T.I. no.: 2020 - 17 Updated: -	Topic: Product optimisation of connector plug
---	--

Datum: 05.06.2020	Priority	Need for action
Betroffene Maschinen: Schaerer Barista	High	As soon as possible
As of date: Production 10.2016 (subsequent information)	X Medium	X On next visit to the machine
	Low	FYI only

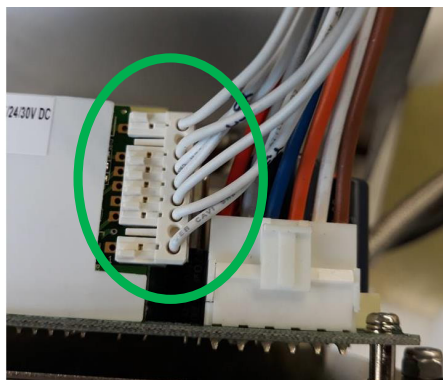
The 7-pin connector plug, which is plugged into the switching power supply at slot X 3, did not have a plug-in coding before the optimisation and can therefore be plugged in incorrectly on machines with a production date up to 09.2016. In this case the front panel of the machine is permanently damaged upon switch-on and the machine displays the error messages 9478 and 9479.

Therefore, on machines with a production date up to 09.2016, it is absolutely important that you pay attention to the correct plug-in position when plugging in the 7-pin plug again on the switching power supply:

Correct plug-in position

Incorrect plug-in position
